Board of Adjustment Hearing, December 12, 2016

Case # C15-2016-0124

# The Church in Austin And Other Neighbors

Objection Letter to the Hotel's Requested Variances (with Exhibits)

Exhibit 2

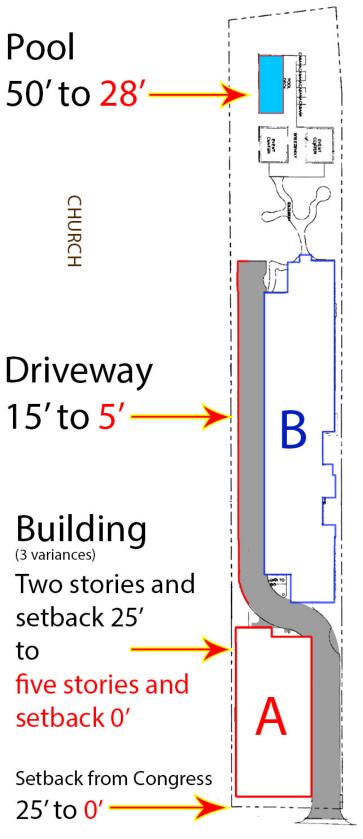
Thank you for hearing our objections as you serve the Austin residents, businesses, and civic organizations. The Church in Austin, hereafter "Church", is located at 2530 S. Congress Avenue. We own the adjoining property to the south of the proposed hotel to be constructed by Krug Development, hereafter "Developer", at 2510 S. Congress Avenue (see Exhibit 1). We and the other impacted neighbors object to the following five (Items 1-5 in chart below) of the hotel's six requested variances: swimming pool setback, driveway setback, and building setback and height limitations from adjoining property. Exhibit 2 is a diagram of these variances. We request that you deny these five variances.

If the variances to the building setback and height limitations from adjoining property are granted, then we object to the sixth variance requesting a decrease from 25 feet right-of-way to 0 feet in the minimum front building line setback from South Congress Avenue.
